2. SITE CHARACTERISTICS

2.1.1 Site Location and Description

Figure 2.4-5 Grand Gulf ESP site vicinity map

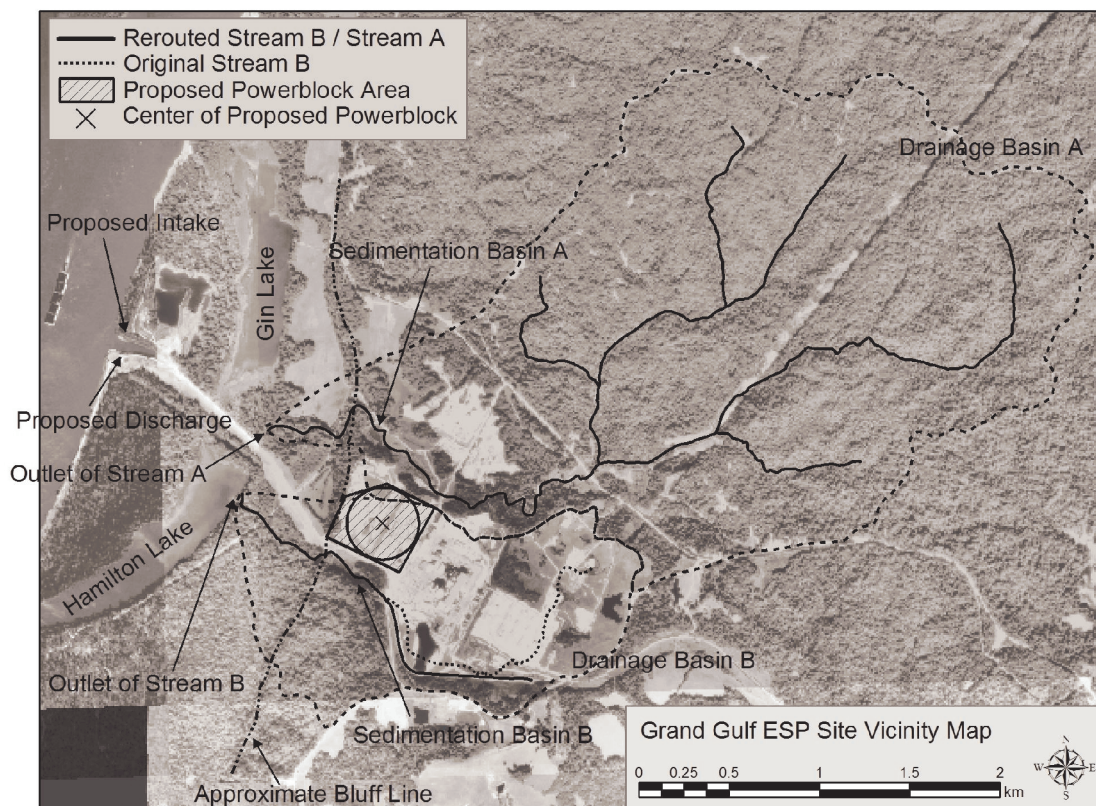
The staff's review of SSAR Figures 2.1-1 and 2.1-2 revealed that, although the coordinates inscribed on these figures for the center of the proposed powerblock are the same as those mentioned in applicant's response to RAI 2.4.1-1, the coordinates do not agree accurately with the position of the center of the proposed powerblock as drawn on these figures. The staff independently created a map to more accurately locate the center of the proposed powerblock. Figure 2.4-5 shows this map.

The map shown in Figure 2.4-5 uses the UTM Zone 15N North American Datum (NAD) 1983 geographic projection. As shown on SSAR Figures 2.1-1 and 2.1-2, the applicant's PPBA is located north of the heavy haul road, east of the bluffs, and southeast of the ESC building. The staff created the polygon labeled "Proposed Powerblock Area" on Figure 2.4-5 closely following the location of applicant's PPBA shown on SSAR Figures 2.1-1 and 2.1-2. The staff overlaid the largest circle that could fit inside the PPBA as shown in Figure 2.4-5. The staff assumed that the center of this circle represents the location of the center of the proposed powerblock. The UTM coordinates determined by the staff for the center of the proposed powerblock are N3,543,266.06 meters and E684,017.28 meters, with reference to the UTM Zone 15N NAD 1983 geographic projection.

The staff also overlaid the applicant-stated coordinates of the center of the proposed powerblock on the map and found that these coordinates place the proposed powerblock approximately 302 feet southwest of the staff-estimated coordinates mentioned above and closer to Stream B. Because of this discrepancy between the coordinates provided by the applicant and the plotted location of the powerblock on Figures 2.1-1 and 2.1-2, the staff cannot determine the actual location of the powerblock on the ESP site. Therefore, the staff required additional information on the true coordinates of the center of the powerblock. This was

Open Item 2.4-1. The staff intended to specify the coordinates of the center of the proposed powerblock as a permit condition subsequent to the satisfactory resolution of Open Item 2.4-1.

In response to Open Item 2.4-1 (Response to Request for Additional Information to Resolve the Grand Gulf Early Site Permit draft Safety Evaluation Report Open Items, System Energy Resources, Inc., June 21, 2005), the applicant stated that the UTM coordinates indicated in the SSAR, ER, and Environmental Policy Institute documents were inaccurate because of an error in a spreadsheet which was used to calculate UTM coordinates corresponding to Mississippi West grid coordinates. The applicant converted the coordinates of the center of the ESP powerblock, N550,099 feet and E277,346 feet in the Mississippi West grid coordinate system, to N3,543,261 meters and E684,018 meters in the UTM Zone 18 NAD 83 projection system using USACE software Corpscon Version 6.0. The applicant revised Figures 2.1-1, 2.1-2, 2.2-4, 2.4-1, 2.4-10, and 2.4-33 of the SSAR. The applicant also revised SSAR Sections 1.2, 2.1.1.1, and 2.4.1.1; Part 1, “Administrative Information,” in Section 1.1; Part 4, “Emergency Planning Information,” and Figures 2-1 and 2-3; and Section 2.1.1, ER Figures 2.1-1, 2.2-1, 2.3-1, 2.3-7, 2.3-12, and 2.3-20; and ER Sections 1.1, 2.1, 2.3, and 4.5.1 to include corrected UTM coordinates.

Figure 2.4.14-1 Areal extent of proposed facility boundaries

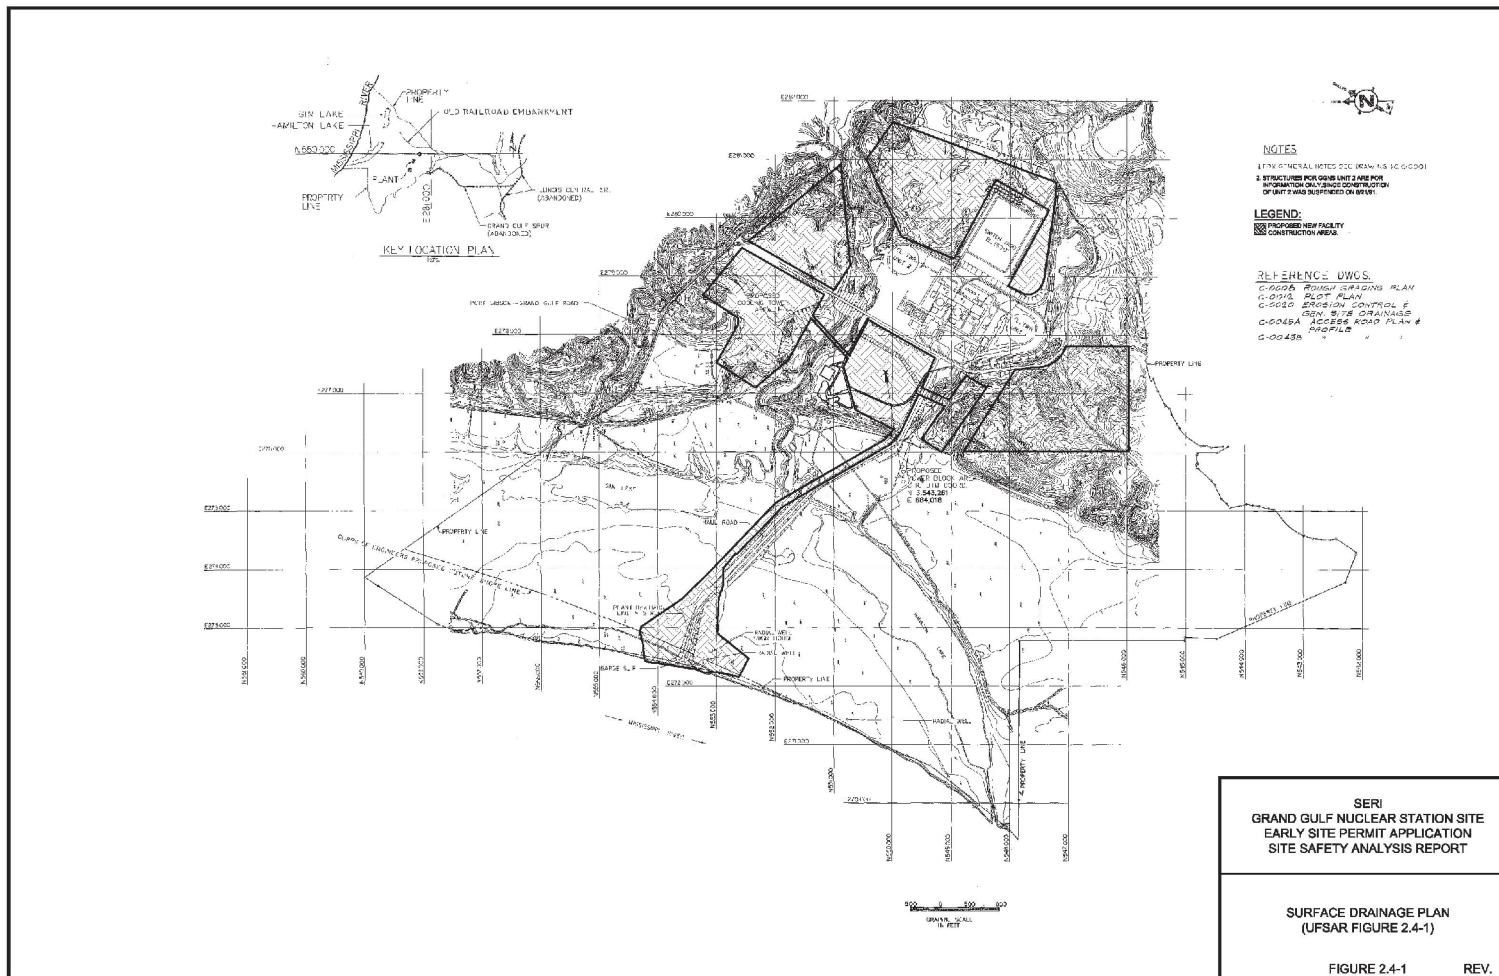
SITE CHARACTERISTIC	VALUE
Proposed Facility Boundaries	SSAR Figure 2.1-1 shows the areal extent of proposed facility boundaries. This figure is reproduced below as Figure 2.4.14-1. The bounding coordinates of the ESP site are a site characteristic. During construction, the ESP site could be disturbed up to a depth ranging from 35 to 140 feet plus some additional excavation.
Site Grade	132.5 feet above MSL
Highest Ground Water Elevation	70 feet below grade; 62.5 feet above MSL; perched water may be present between the site grade at 132.5 feet above MSL and the water table at 62.5 feet above MSL.
Flood Elevation	Flood water elevation at the ESP site caused by local intense precipitation will be established by the COL applicant using local intense precipitation values established in Section 2.4.2.3 of this SER. Local intense precipitation itself is a site characteristic, listed below.
Local Intense Precipitation	19.2 in./h, of which 6.2 in. falls during the first 5 minutes.
